Access Compliance Report

Public Rights-of-Way

(Curb Ramps)

Intersection ID: 7091	Main Street: BROOKSHIRE_BV	Cross Street: HOVIS_RD	Location:	N
ADA ID: 5D8F8067636E	Ramp Type: BlendTrans2	Initial Pass/Fail: Pass	Overall Compliance: No	Severity Score: 2.75

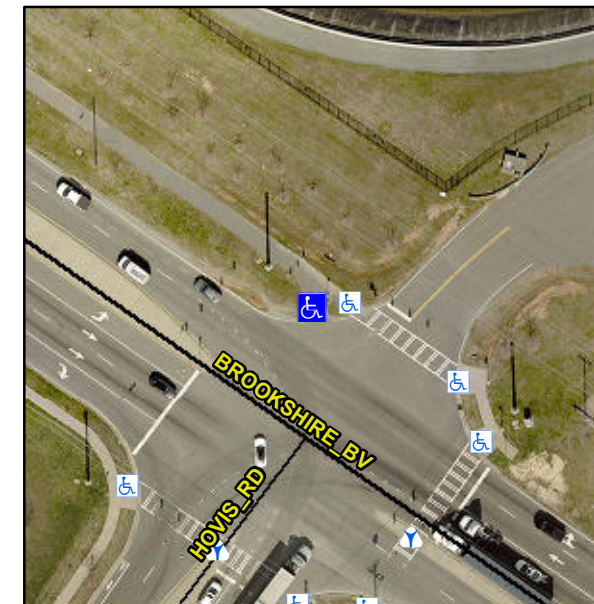
Surveyor Notes:

NO CURB

PROW/ADA:

R304.5.3, R305.1.4, R305.2

Possible Solutions:

Remove & Replace Curb Ramp With Two New Directional Ramps or Equivalent.
